Affected Date Code: 03/01/2023

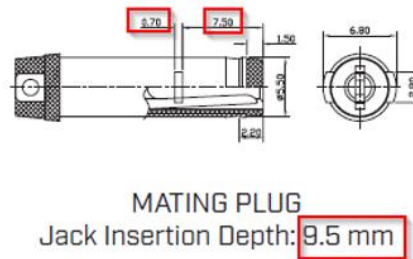
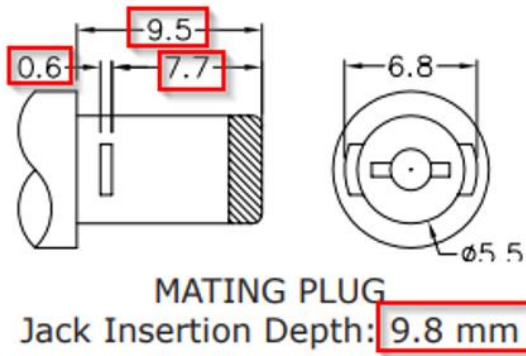
PREVIOUS CUI DEVICES DETAIL / IMAGE			NEW CUI DEVICES DETAIL / IMAGE		
	MATERIAL	PLATING	DESCRIPTION	MATERIAL	PLATING/COLOR
center pin	copper	nickel	center pin	brass	nickel
terminal 1	brass	silver	terminal 1	brass t=0.30	silver
terminal 2	copper alloy	silver	terminal 2	bronze t=0.25	silver
terminal 3	brass	silver	terminal 3	brass t=0.30	silver
plastic	PBT		cover	PBT (UL94V-0)	black
			housing	PBT (UL94V-0)	black
